A1 Birtley to Coal House

Scheme Number: TR010031

**EXA/D4/006 Addendum to Transport
Assessment Report**

**The A1 Birtley to Coal House
Development Consent Order 20[xx]**

Figure 2-1 Proposed Lane Narrowing

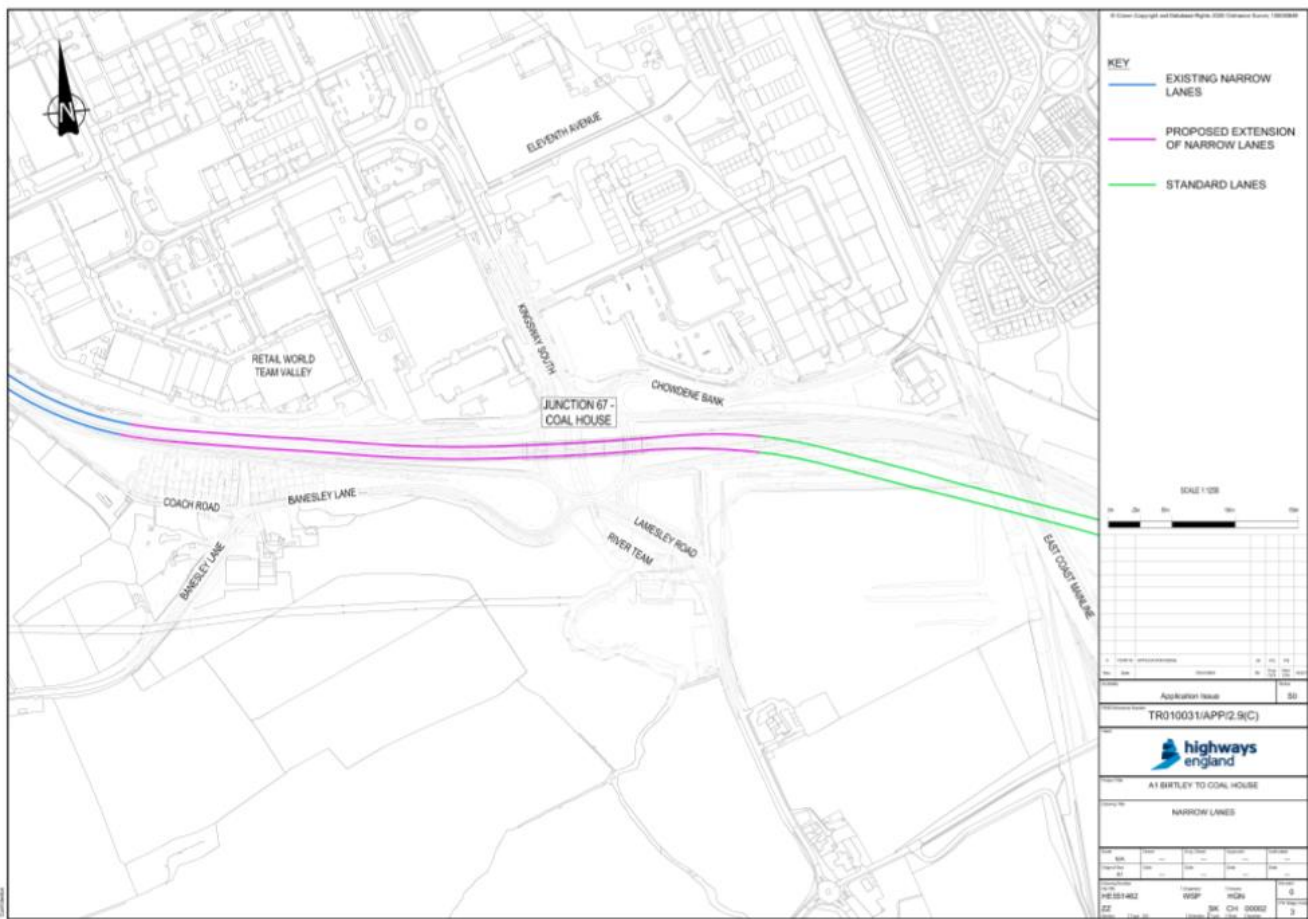
- 2.1.1 The Application as made proposed to provide full width lanes through the entire length of the A1 between junction 67 (Coal House) and junction 65 (Birtley). This is as shown on the General Arrangement Plan [APP-010] and Works Plans [AS-011]. Narrow lanes are already in place and operational to the north of junction 67.
- 2.1.2 The Applicant has now requested that the application is amended to allow provision for narrower lanes to be extended by up to 750m south of junction 67 (Coal House) and over the Kingsway Viaduct. The figure 2-1 below illustrates the proposed narrow lane provision.

- 2.1.3 The Applicant has undertaken a traffic impact assessment of including the narrower lanes option at junction 67 (Coal House) and over Kingsway Viaduct and the findings are set out within this TAA.
- 2.1.4 **Table 2.1** below presents the cross-sectional widths of the carriageway proposed as part of the current application as described in the TAR [APP-173] and proposed amendment to the lane widths to allow implementation of narrower lanes.
- 2.1.5 Scenario A (Application) represents the lane widths currently proposed in the

- 2.1.6 The narrower lane widths outlined in the **Table 2-1** for Scenario B (Proposed Change) show that there would be no change in lane width for proposed Lane 1. The width of proposed Lane 2 will be amended from 3.7m to 3.5m and width of proposed Lane 3 will be amended from 3.65m to 3.2m.
